**MASTER DEVELOPMENT DRAINAGE PLAN AMENDMENT**  
**FOR**  
**WATerview EAST**  
**&**  
**PRELIMINARY DRAINAGE PLAN**  
**FOR**  
**TRAILS AT ASPEN RIDGE**

June 2019

Project No. 19.866.008

PUDSP-19-001

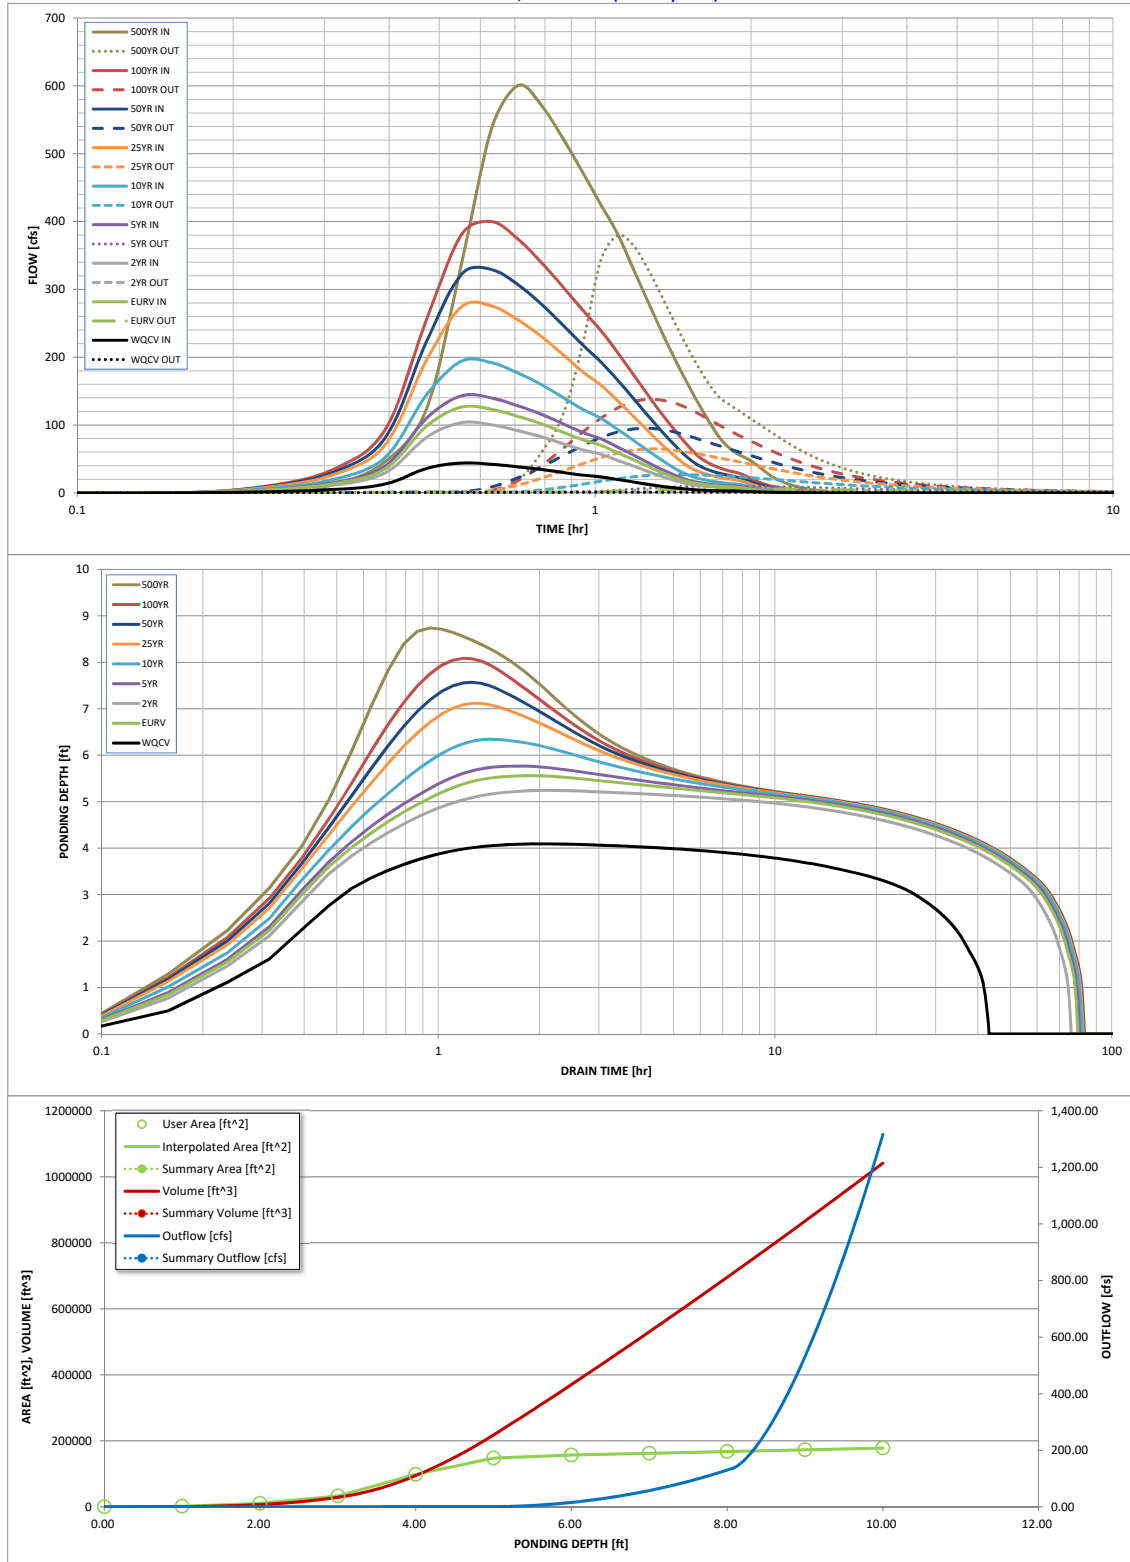
Revise so the entire 100yr discharges through the outlet pipe and not partially over the emergency spillway

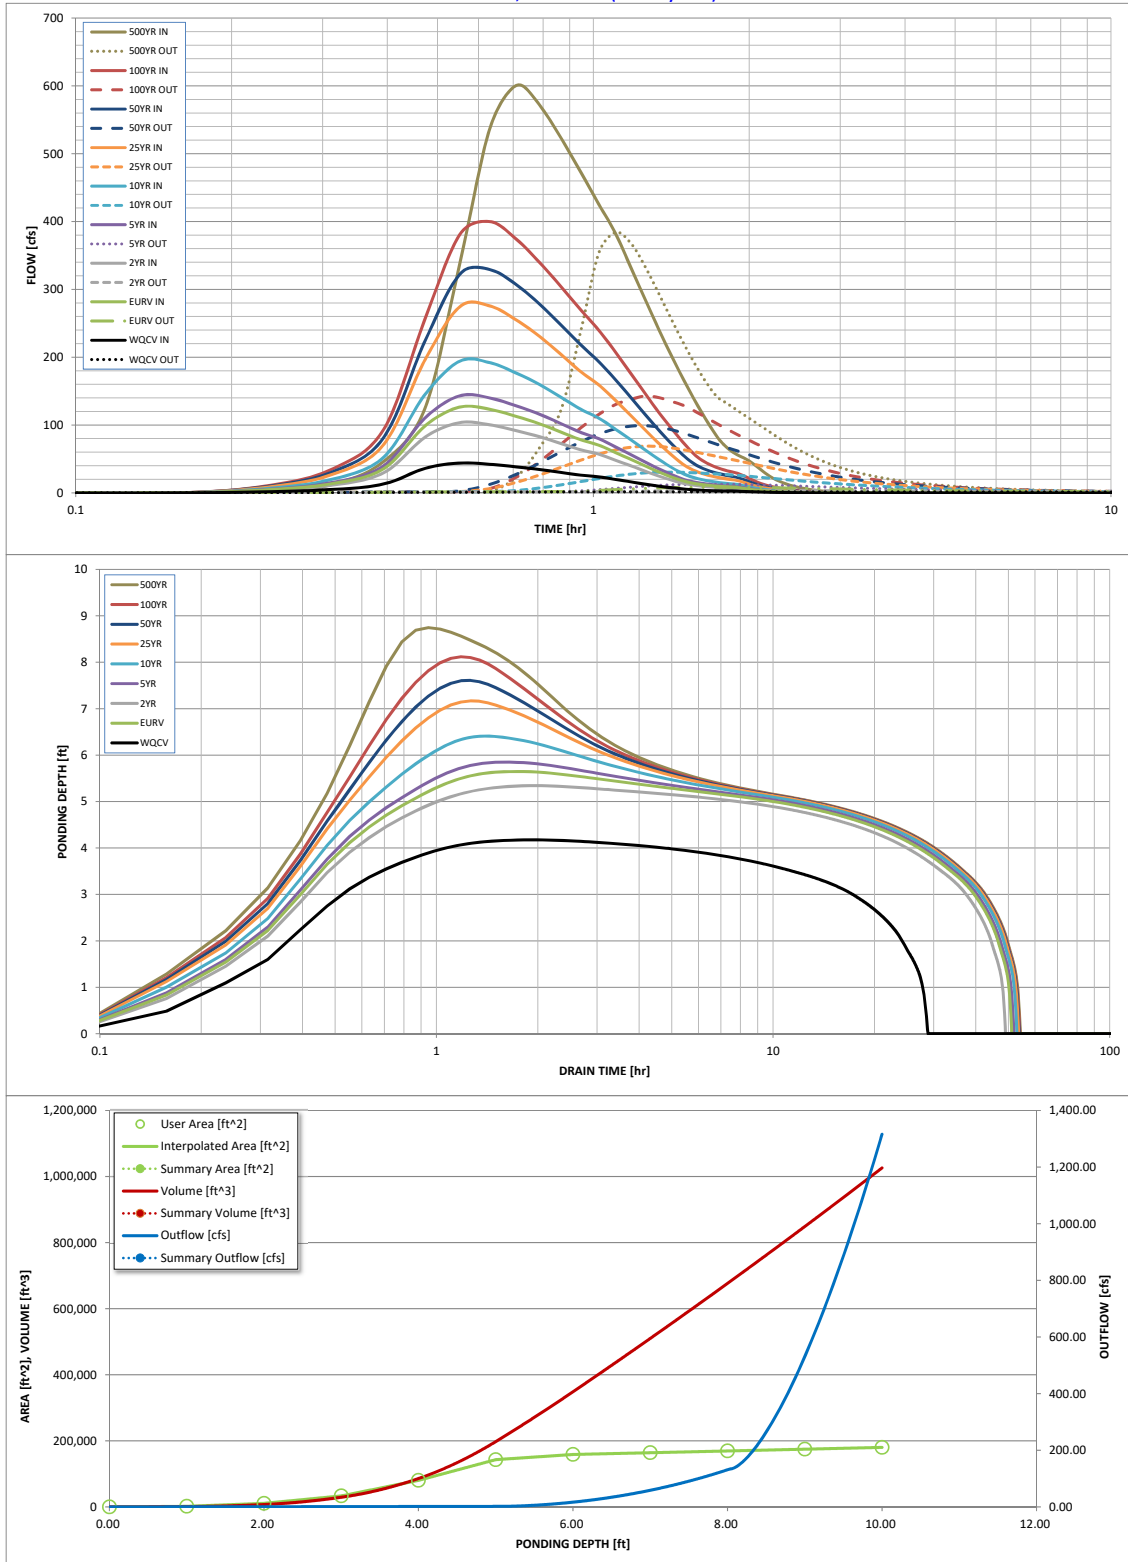
Ratio for all design storm must be equal to or less than predevelopment flow.

Revise so the entire 100yr discharges through the outlet pipe and not partially over the emergency spillway

DESIGNED BY: JTS	SCALE	DATE ISSUED: JUNE 2019	DR-02
DRAWN BY: JTS	HORIZ:	SHEET NO. OF 2 SHEETS	
CHECKED BY:	VERT:

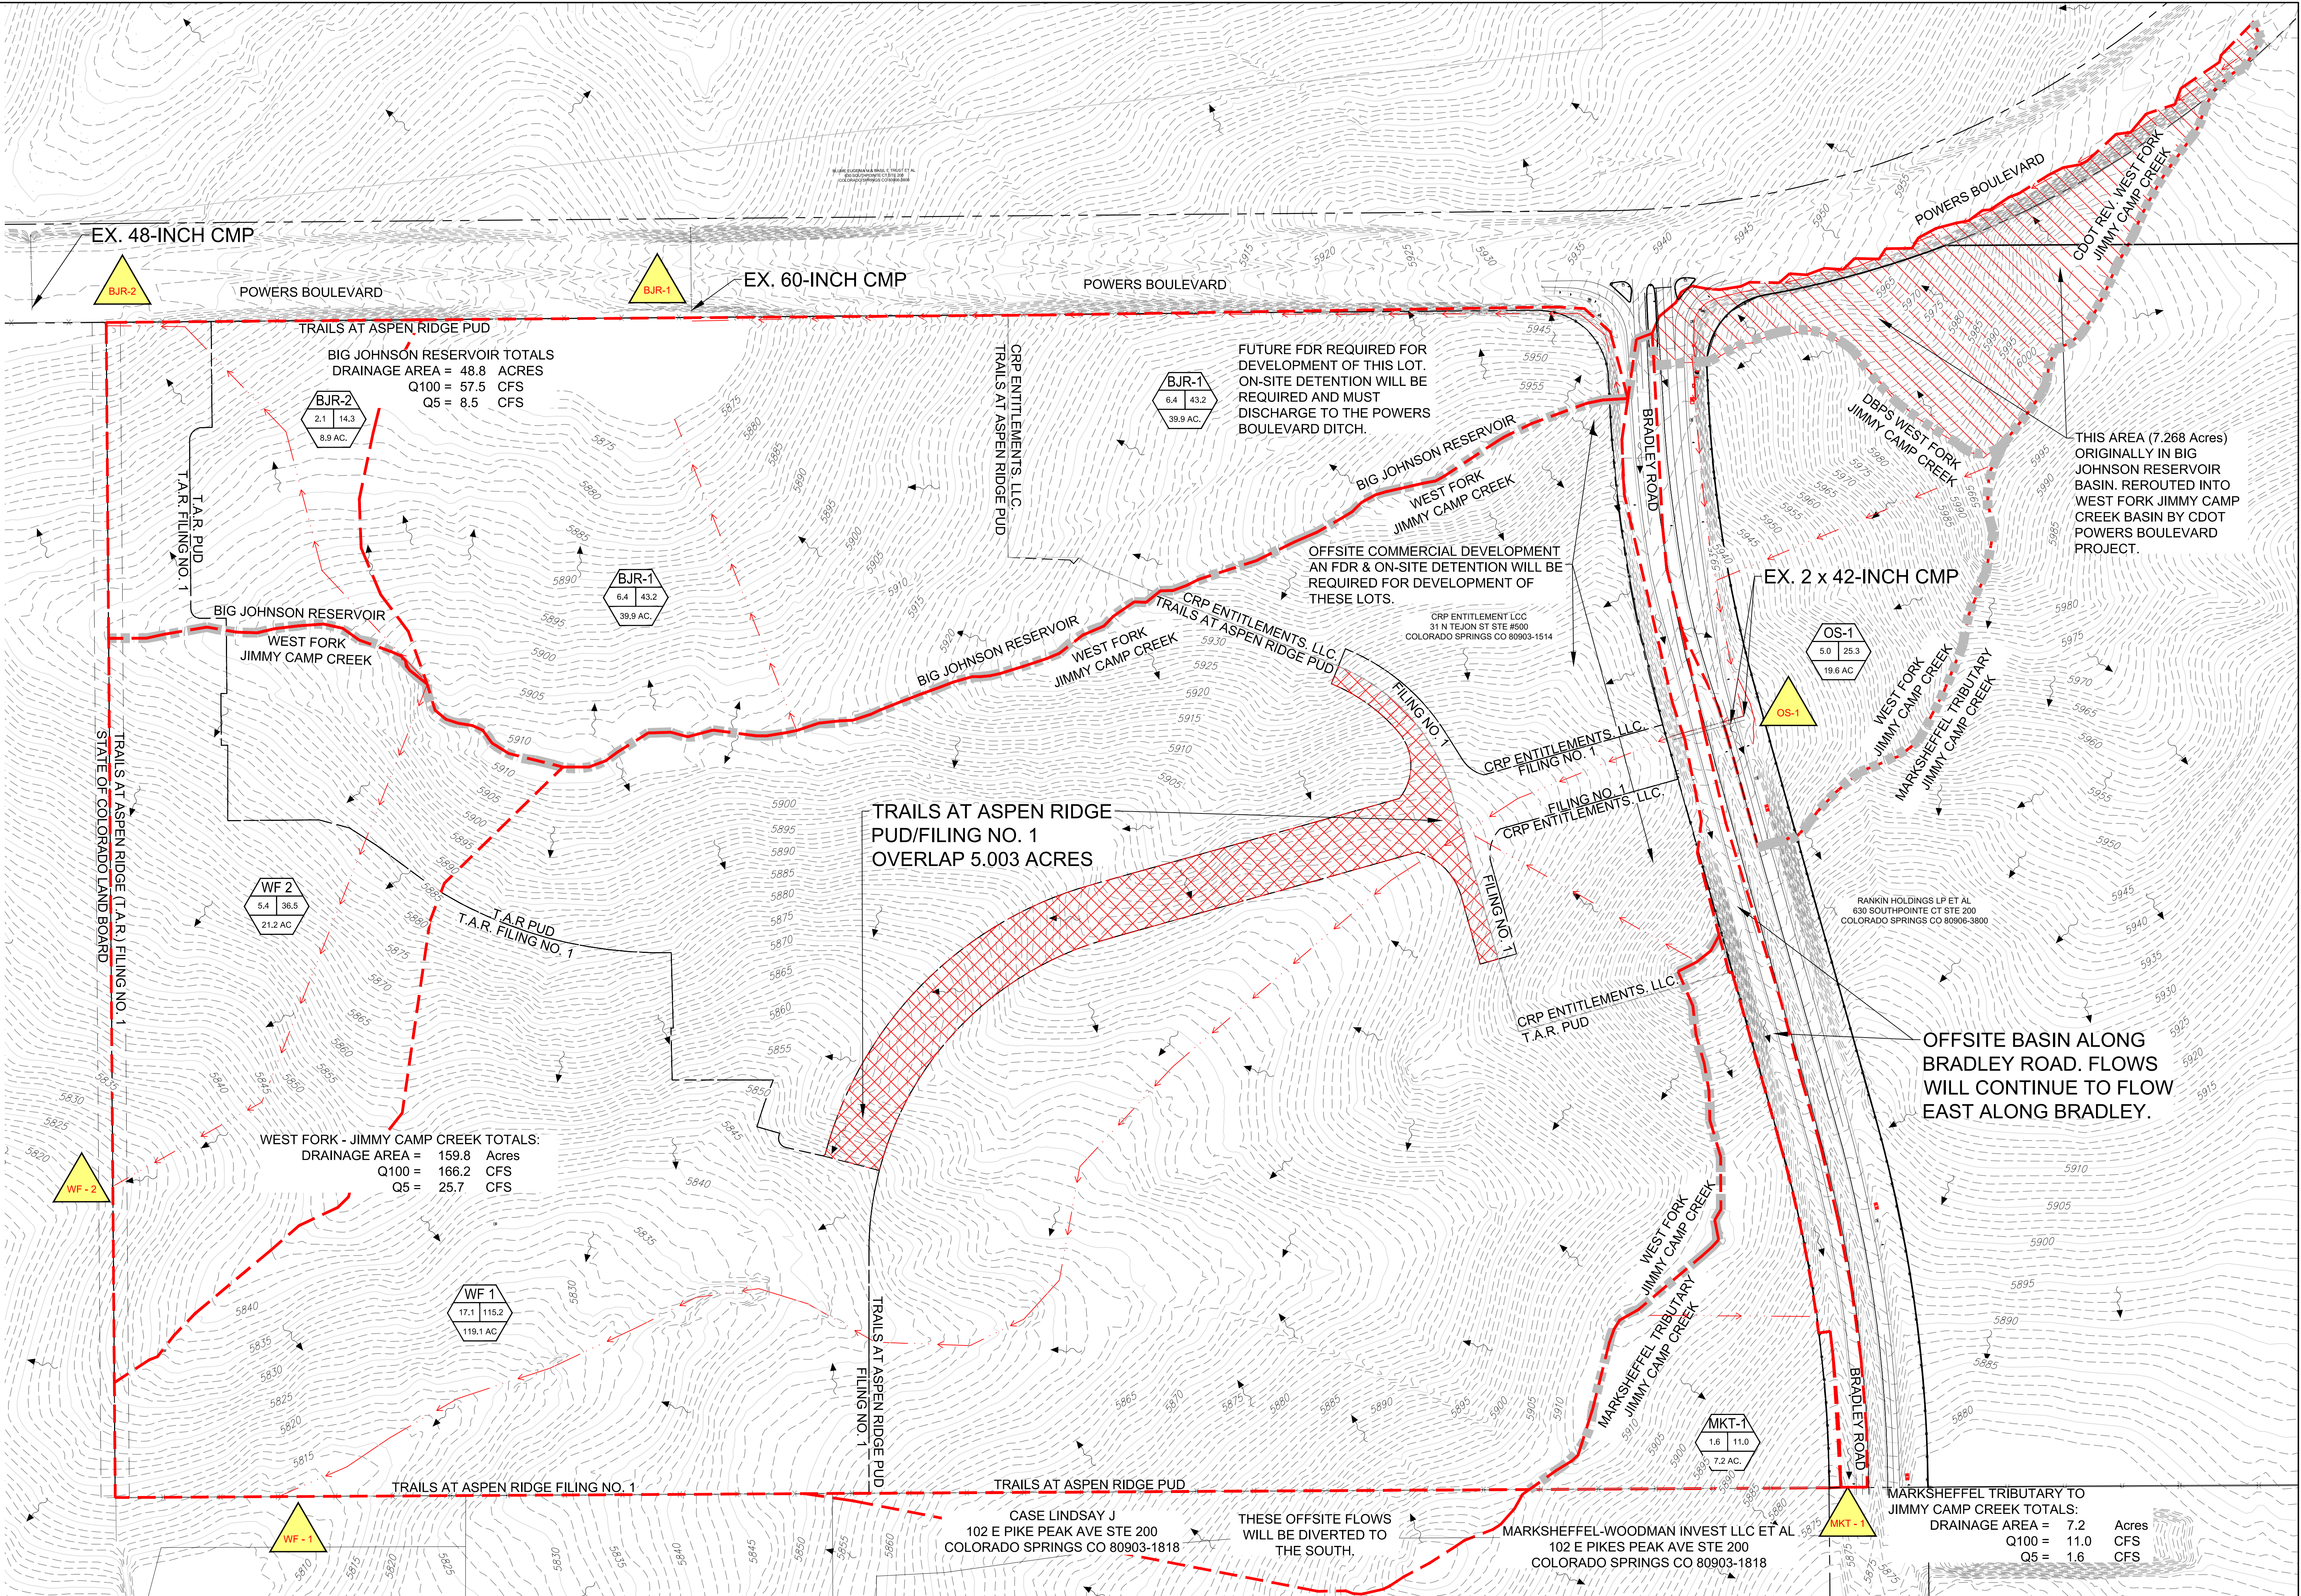
Provide a sub-basin for the backyard flow draining off-site. Permanent WQ control measure is required unless an it is an applicable exclusion as defined in the updated ECM Appendix I. On the basin narrative identify the specific exclusion.
